Stage 1 Road Safety Audit and Response Report

**Mowbray Development,
North of Horsham**

Proposed RMA3

Stage 1 Road Safety Audit

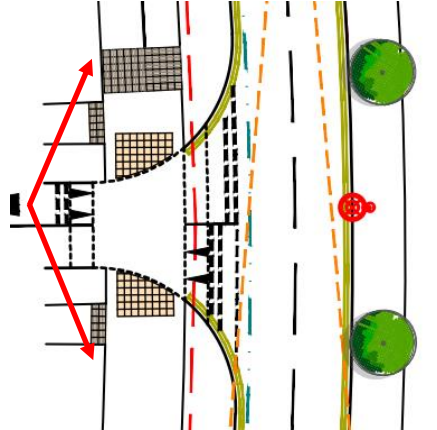
Location: Proposed side road crossing points

Summary: Clarification of priority to all users

The proposed scheme, and wider Mowbray development, includes various crossing points for pedestrians and cyclists. Some of these give formal priority to crossing users, whilst others are more conventional crossing points, where those wishing to cross should typically give way to passing vehicles. In order for the arrangement to operate safely at each location, it will be important that pedestrians, cyclists and motorists can clearly identify when they will need to give way. Otherwise, there may be a heightened risk of associated conflict.

It is recommended that a consistent approach is adopted, both within the current scheme, and adjoining phases of the development. As well as any signing/markings proposed, a consistent approach to each type of crossing, in terms of its physical design and appearance, should ensure that users will become familiar with each arrangement and can readily distinguish between crossings with pedestrian/cycle priority, and those where footway/cycleway users should give way to passing traffic.

RSA Problem Ref.	RSA Problem	RSA Recommendation	Design Organisation's Response	Overseeing Organisation's Response	Agreed RSA Action
2.1	The proposed scheme, and wider Mowbray development, includes various crossing points for pedestrians and cyclists. Some of these give formal priority to crossing users, whilst others are more conventional crossing points, where those wishing to cross should typically give way to passing vehicles. In order for the arrangement to operate safely at each location, it will be important that pedestrians, cyclists and motorists can clearly identify when they will need to give way. Otherwise, there may be a heightened risk of associated conflict.	It is recommended that a consistent approach is adopted, both within the current scheme, and adjoining phases of the development. As well as any signing/markings proposed, a consistent approach to each type of crossing, in terms of its physical design and appearance, should ensure that users will become familiar with each arrangement and can readily distinguish between crossings with pedestrian/cycle priority, and those where footway/cycleway users should give way to passing traffic.	The Design Organisation partially accepts the Audit Team's recommendation. The crossings have been designed in accordance with approved cycling strategy. The segregated footway-cycleway alongside the primary road is designed with raised tables at crossing points on the secondary roads where pedestrians and cyclists have priority over vehicular traffic. Crossing points for the pedestrian-only footway alongside the primary road are designed as conventional in-line uncontrolled crossings. This approach is consistent along the full length of the RMA3 road, as currently designed, as well as with other recently designed and approved primary road infrastructure within the wider Mowbray development.

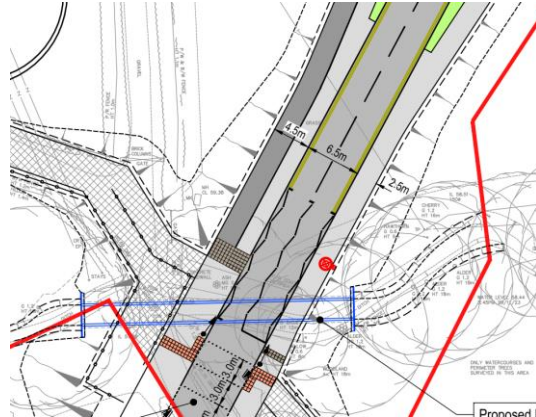
Location: Crossing points with pedestrian/cycle priority

Summary: Provision of adequate visibility from side road

Whilst the visibility splay drawings include details of proposed visibility at each junction, it will also be important that drivers emerging from the side roads have sufficient visibility of any approaching pedestrians/cyclists, in order that they can give way at the crossing point if necessary. If visibility is restricted, this could lead to a heightened risk of collisions at the crossing points, particularly involving cyclists, who will often be approaching the crossing point at higher speed than pedestrians.

It is recommended that appropriate visibility splays are identified and kept clear of obstruction at each side road crossing point where pedestrians and cyclists will have priority.

2.2	Whilst the visibility splay drawings include details of proposed visibility at each junction, it will also be important that drivers emerging from the side roads have sufficient visibility of any approaching pedestrians/cyclists, in order that they can give way at the crossing point if necessary. If visibility is restricted, this could lead to a heightened risk of collisions at the crossing points, particularly involving cyclists, who will often be approaching the crossing point at higher speed than pedestrians.	It is recommended that appropriate visibility splays are identified and kept clear of obstruction at each side road crossing point where pedestrians and cyclists will have priority.	The Design Organisation accepts the Audit Team's recommendation. Where vehicles are only giving way to pedestrians and cyclists visibility splays have been added in accordance with LTN 1/20 (paras 5.8.1 to 5.8.6). These splays assume an X-distance of 2.4 metres and a Y-distance of 17 metres (20kph approach speed). At the junction with the main carriageway, visibility splays are based on MfS guidance.

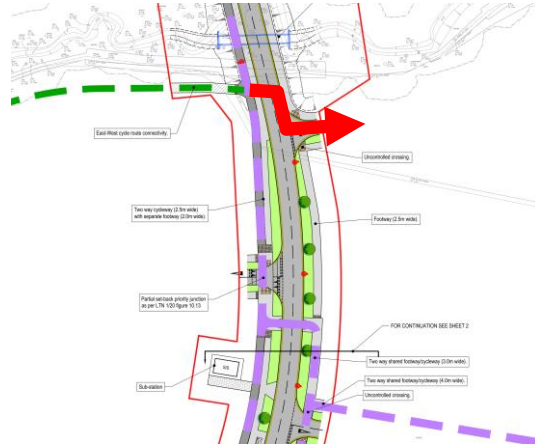
Location: Footway/cycleway/bridleway adjacent to watercourse/slopes

Summary: Sudden drop/gradient could pose a risk to users

It appears from the drawings that there will be slopes alongside some sections of footway/cycleway/bridleway. There will also be culverted watercourses running through the site. Depending on the severity of any adjacent drops or gradient, users of these facilities could be at risk if they are not adequately protected. This risk could be heightened during the hours of darkness, when any adjacent hazards may be less obvious to users.

It is recommended that the likely severity of any slopes or drops is assessed and additional measures to protect users introduced if appropriate.

2.3	It appears from the drawings that there will be slopes alongside some sections of footway/cycleway/bridleway. There will also be culverted watercourses running through the site. Depending on the severity of any adjacent drops or gradient, users of these facilities could be at risk if they are not adequately protected. This risk could be heightened during the hours of darkness, when any adjacent hazards may be less obvious to users.	It is recommended that the likely severity of any slopes or drops is assessed and additional measures to protect users introduced if appropriate.	The Design Organisation accepts the Audit Team's recommendation. The fencing requirements along this section will be assessed and confirmed during the detailed design stage. This will consider the risks that may apply to all road users as might be reasonably anticipated.

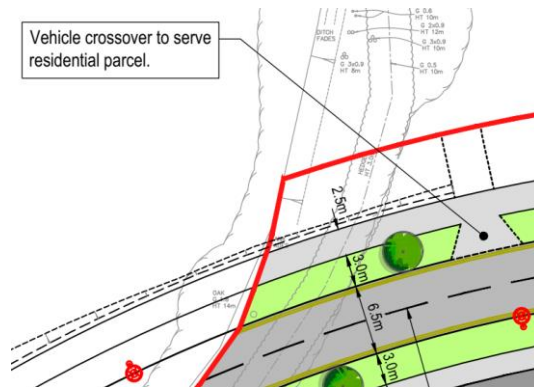
Location: East-West Cycle Route

Summary: Connectivity with eastern side of carriageway

It is noted from the Pedestrian and Cycle Strategy that a cycle route is to join RMA3 from the west as shown above. It is possible that some cyclists will wish to connect directly with the eastern side of the carriageway. For example, to reach the side road as indicated by the red arrow above. However, this could lead to random/inappropriate crossing movements in this area if a suitable crossing point/connectivity are not provided.

It is recommended that the need for an additional crossing facility in the above area is investigated and incorporated into the detailed design as appropriate.

RSA Problem Ref.	RSA Problem	RSA Recommendation	Design Organisation's Response	Overseeing Organisation's Response	Agreed RSA Action
2.4	It is noted from the Pedestrian and Cycle Strategy that a cycle route is to join RMA3 from the west as shown above. It is possible that some cyclists will wish to connect directly with the eastern side of the carriageway. For example, to reach the side road as indicated by the red arrow above. However, this could lead to random/inappropriate crossing movements in this area if a suitable crossing point/connectivity are not provided.	It is recommended that the need for an additional crossing facility in the above area is investigated and incorporated into the detailed design as appropriate.	The Design Organisation accepts the Audit Team's recommendation. The need or otherwise for an additional crossing will be reviewed at the detailed design stage.

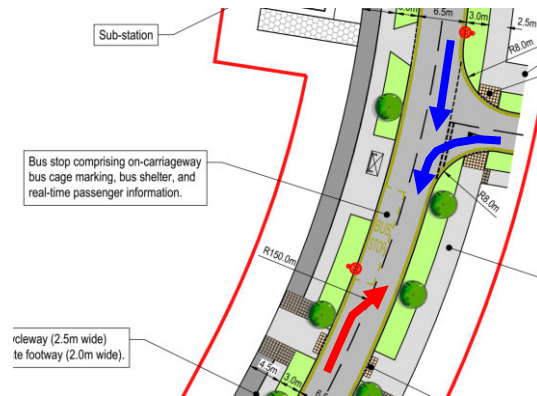
Location: Proposed vehicle crossover accesses

Summary: Potential conflict if inter-visibility between emerging drivers and footway/cycleway users is restricted

The proposals will include a vehicle crossover arrangement at a number of locations, providing access to residential parcels and sub-stations. If drivers emerging from these locations do not have adequate visibility along the adjoining footway or cycleway, this could lead to a heightened risk of conflict with those using these facilities.

It is recommended that appropriate visibility splays are identified and kept clear of obstruction at the vehicular egress from each residential parcel/sub-station.

2.5	The proposals will include a vehicle crossover arrangement at a number of locations, providing access to residential parcels and sub-stations. If drivers emerging from these locations do not have adequate visibility along the adjoining footway or cycleway, this could lead to a heightened risk of conflict with those using these facilities.	It is recommended that appropriate visibility splays are identified and kept clear of obstruction at the vehicular egress from each residential parcel/sub-station.	Where vehicle crossovers cross footways visibility splays that are a minimum of 2 metres x 2 metres will be available and remain clear of obstruction. It should be noted that vehicles will only need to access the sub-stations on a very infrequent basis.
